DELHI DEVELOPMENT AUTHORITY
MASTER PLAN SECTION

F.1(27)93-MP

Minutes of Technical Committee meeting held on 28.5.93 at 11.00 A.M. in the V.C.'s Conference Room, Delhi Development Authority, I.N.A., New Delhi.

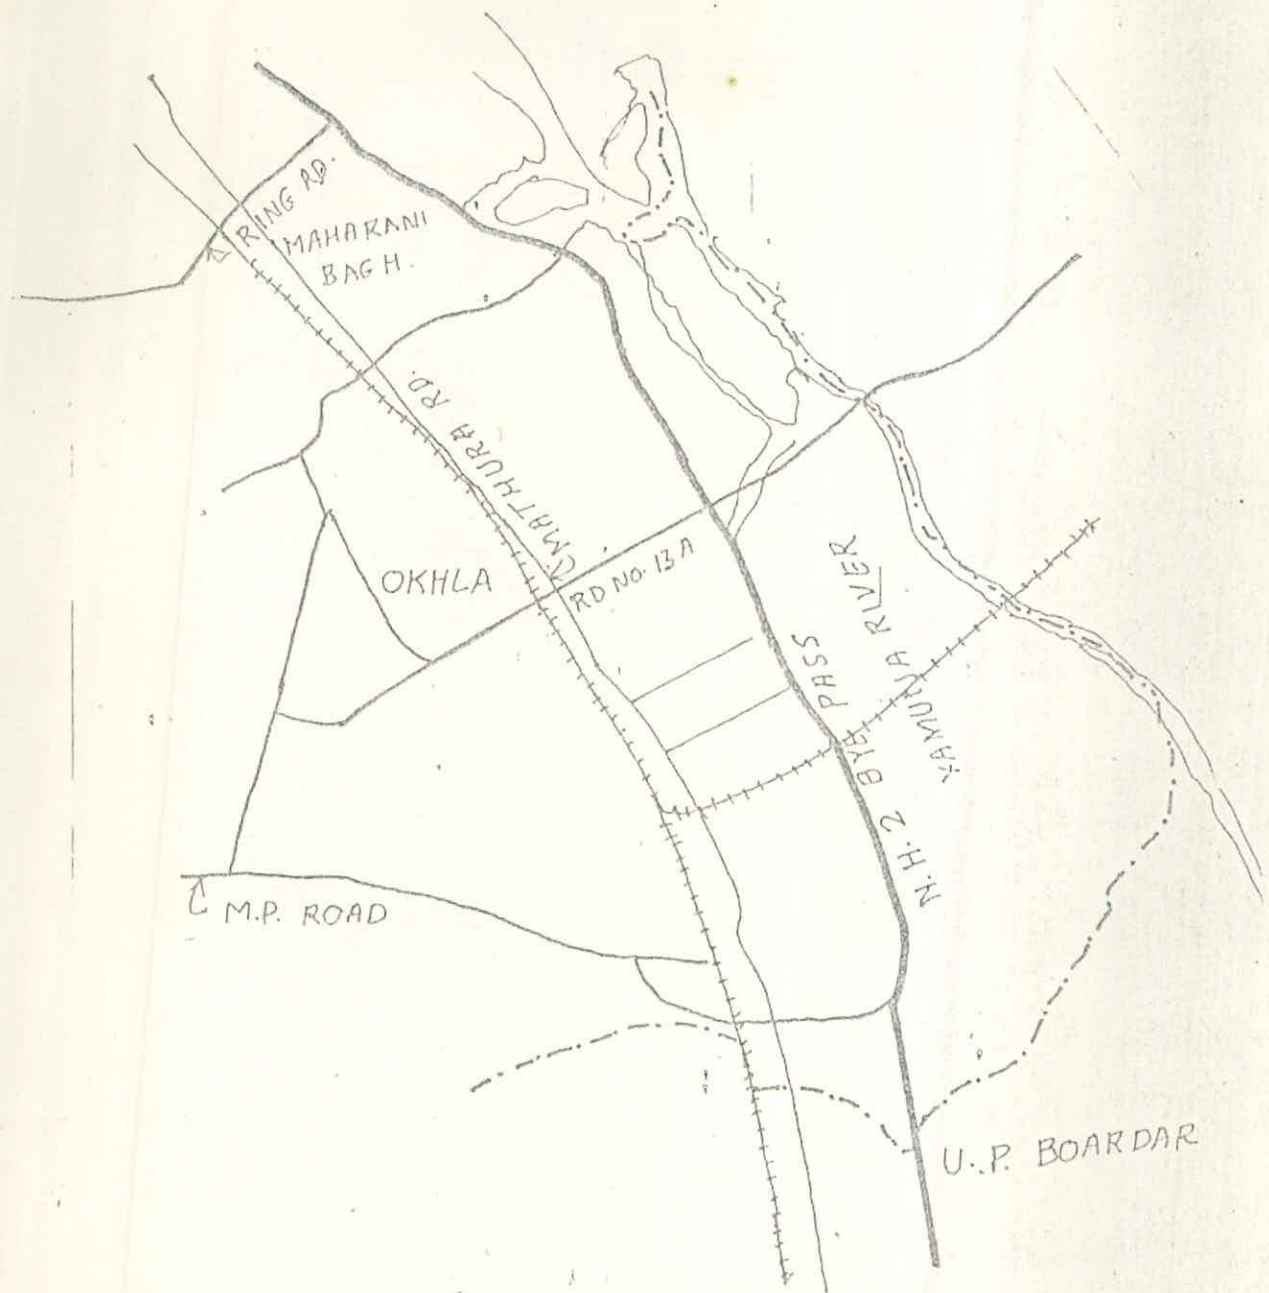
Alternative-II : Almost same alignment in the East of Agra Canal as proposed in MPD-2001. But, this alignment will affect a number of bungalows/lake and park developed by H.P. Govt.

i.e. "critical" in terms of site/cost constraints. However, the section covering the portion along Jasola Village has been designated as 'R' i.e. "less R/W" is available within the proposed 90 mts. R/W. The section between Jasola Village and Madanpur Khadar has been designated as C-2 i.e. "critical" in terms of site/cost constraints.
